RESPONSES TO EPA COMMENTS ON JOHNNY M MINE EECA, DRAFT OF DECEMBER 2014

April 16, 2015

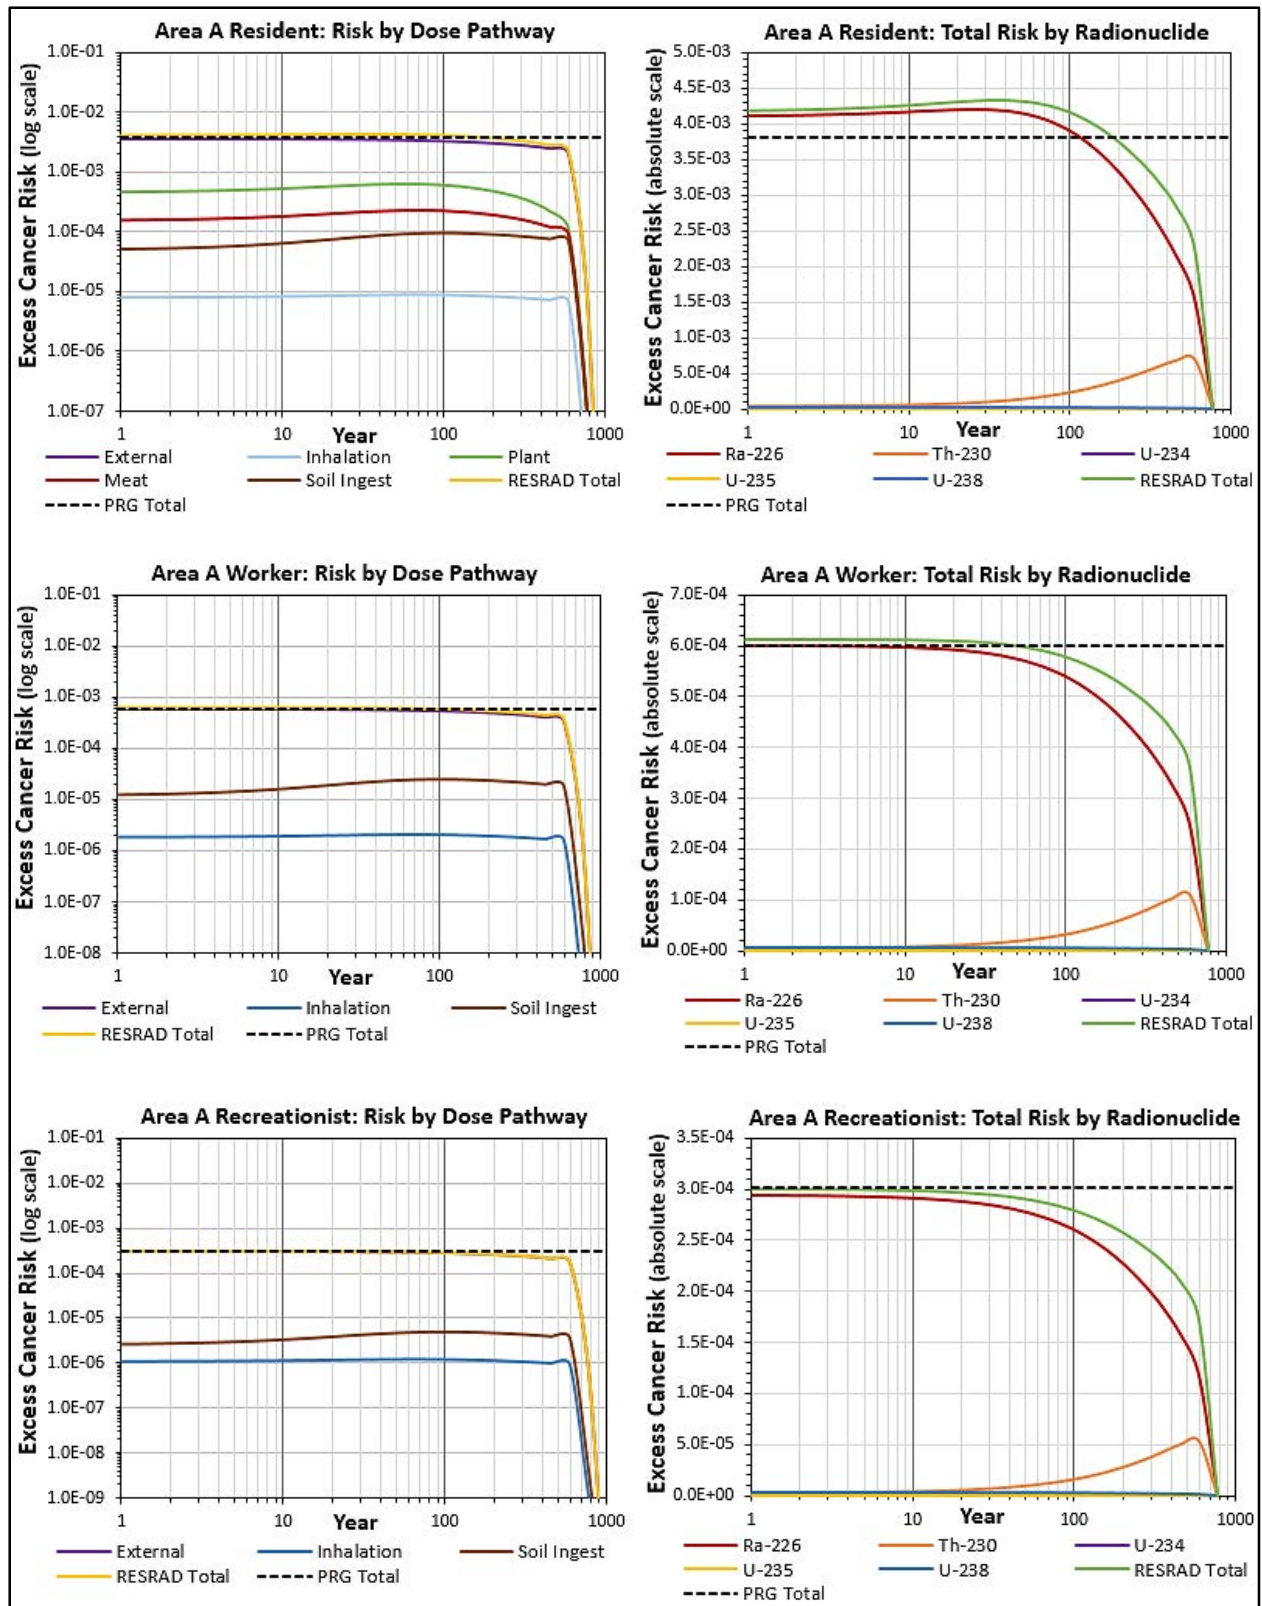
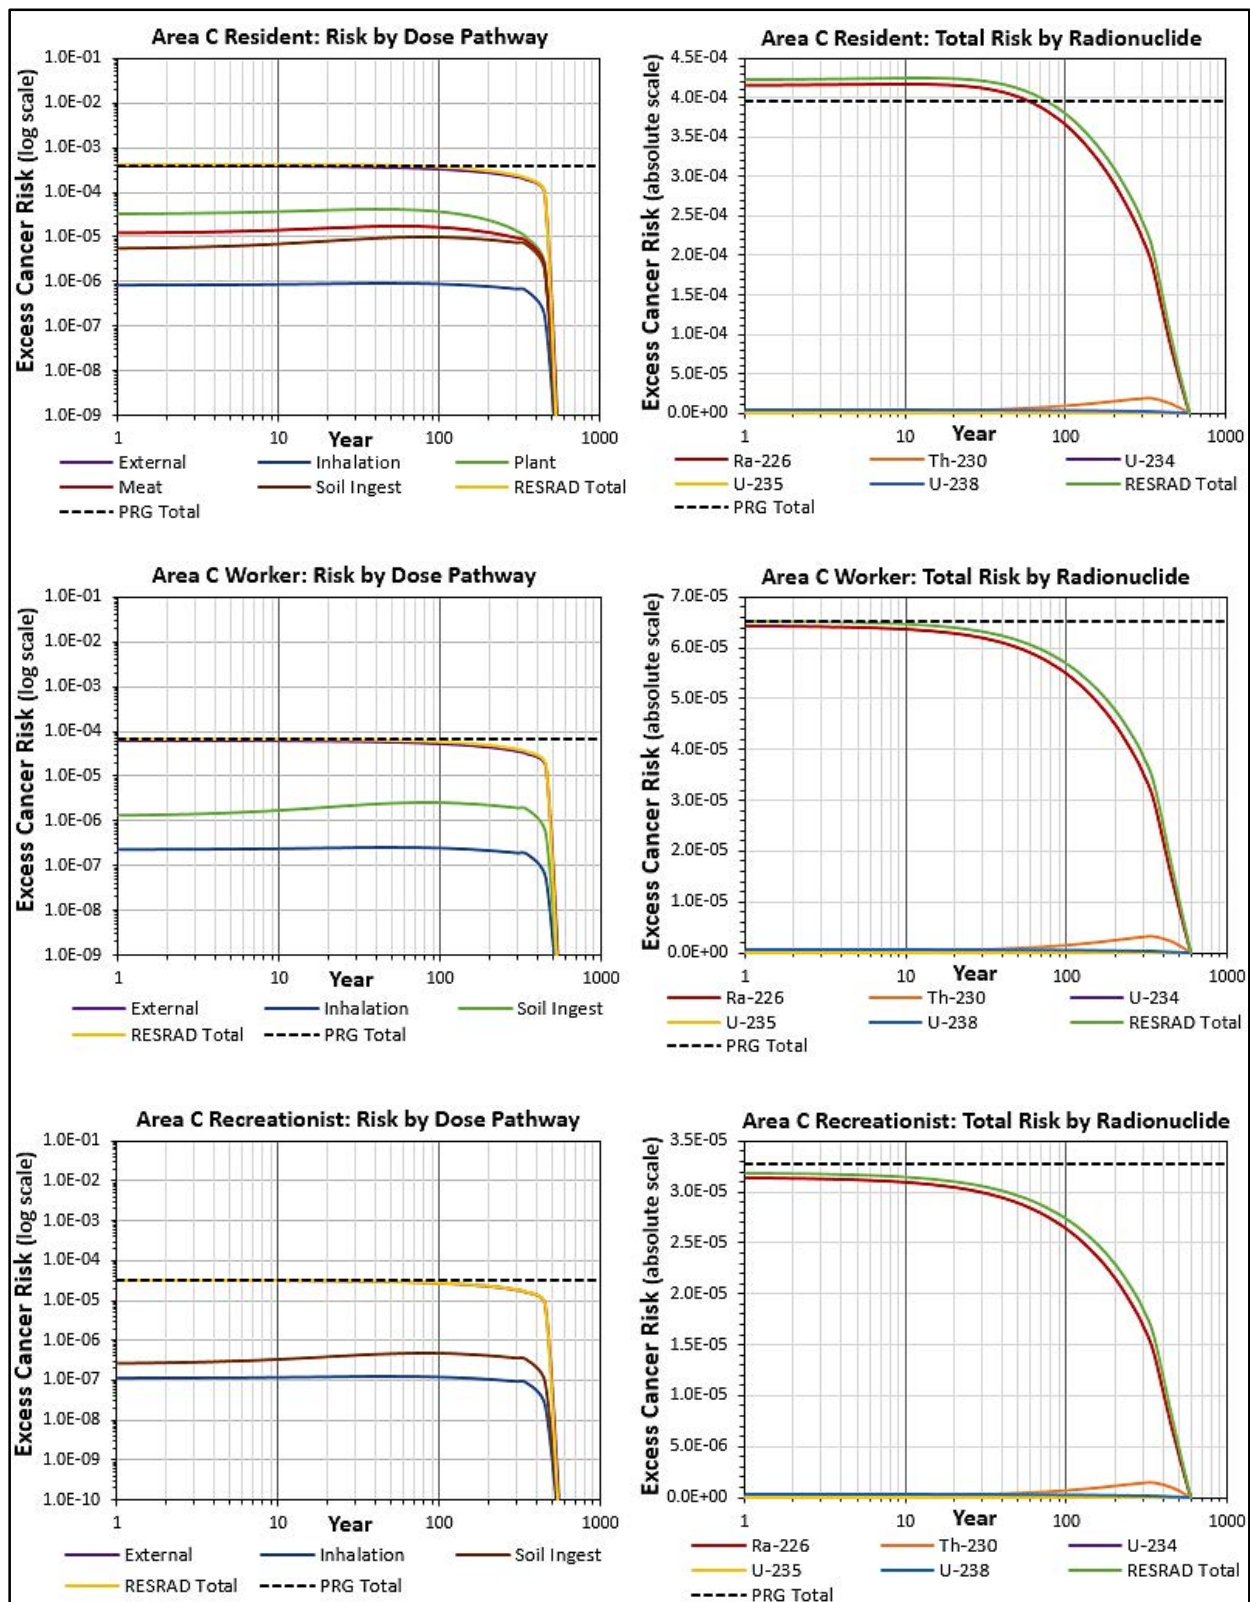
Comment No.	Section(s)	Page #	Comment/Edit	Response
				RESRAD modeling is considered more appropriate for evaluating long-term risks at this site.
Radiological-2	Figures 9&10		<i>Risk estimates: Figures 9 & 10 present the risk estimates generated using RESRAD for the Site. These figures depict a dramatic fall-off in risk at about year 800, which is not explained in the text. Please provide additional information and clarification for this effect if you wish to continue using the RESRAD model. See previous comment.</i>	Excess risk from all radionuclides and pathways declines rapidly after about 800 years as radioactive contaminants approach complete depletion from surface soils within the modeled area due to soil erosion, leaching and radioactive decay. This statement will be added to the relevant text in the EE/CA.
Radiological-3	NA	NA	<i>Proposed cleanup criterion: the EE/CA does not present a proposed cleanup criterion, but instead estimates the cost associated with three potential cleanup criteria; 5 pCi/g above background, 2.5 pCi/g above background, and background. Further, there is no discussion on how the Ra-226 concentrations were arrived at. There is clear discussion on CERCLA risk value calculations and how they relate to the assumptions for the three potential receptor groups, all of which is reasonable. EPA believes that a proposed cleanup criterion for each of the proposed potential receptor groups is an integral part of this EE/CA. Please prepare a proposed cleanup criterion based upon a proposed risk from the use of the PRG Calculator (preferred) or RESRAD (with justification) for each of the potential receptor groups. Further, these calculations should compare risk using both the default values in PRG Calculator or</i>	There is no mention of establishing cleanup criteria in the 1993 EPA guidance for “non-time-critical” removal actions. The only requirement in this guidance document is to recommend Applicable or Relevant and Appropriate Requirements (ARARs). The CERCLA acceptable risk range was identified as a potential ARAR. However, the following language has been added to a PRG Section of the EECA: “Preliminary Remediation Goals (PRGs) for soils within Areas A and C were calculated for each receptor scenario using the EPA’s PRG Calculator for Radionuclides (EPA, 2014b). Consistent with the rationale and criteria used to determine PRGs for soil in the EPA’s Five-year Plan for remediation of uranium properties within the Grants Mineral Belt (EPA, 2010a; Weston, 2009), a bounding risk value of 3×10^{-4} was adopted for determination of PRGs for soil within the Johnny M Project Area. Results of this modeling (Table 3) indicate that PRGs for the most conservative receptor scenario (resident) and most limiting (restrictive) radionuclide (radium-226)

Comment No.	Section(s)	Page #	Comment/Edit	Response
			<i>RESRAD (with justification), and site-specific values representative of the Johnny M site. Cost estimates may need to be amended if the cleanup values are different than those discussed above.</i>	<p>are consistent with the 2.5 pCi/g above background soil cleanup level adopted by the EPA for remediation of uranium properties within the Grants Mineral Belt (Weston, 2009). Hecla plans to use the 2.5 pCi/g of radium-226 above background for areas outside of those addressed by ICs. For areas addressed by ICs, Hecla plans to meet or exceed one of the alternative PRGs in Table 3.”</p> <p>In response to EPA’s request, a section has been added to the EE/CA in which PRGs for soils for each receptor scenario were developed using PRG Calculator. The calculated PRG for radium-226 in the residential scenario in both areas is consistent with the 2.5 pCi/g above background concentration assumed in one of the volume estimation scenarios presented in the EE/CA. This value was selected based on data provided in Appendix B of “Quality Assurance Sampling Plan for Grants Mineral Belt Structures Assessment Cibola and McKinley Counties, New Mexico,” (EPA, 2010).</p> <p>Background was selected to provide an upper bound of the volume estimate. The UMTRCA standard, 5 pCi/g radium-226 above background, was selected to provide a lower bound of the volume estimate. 2.5 pCi/g radium-226 above background was selected to provide a volume estimate based on the expected cleanup criterion for a residential scenario.</p>
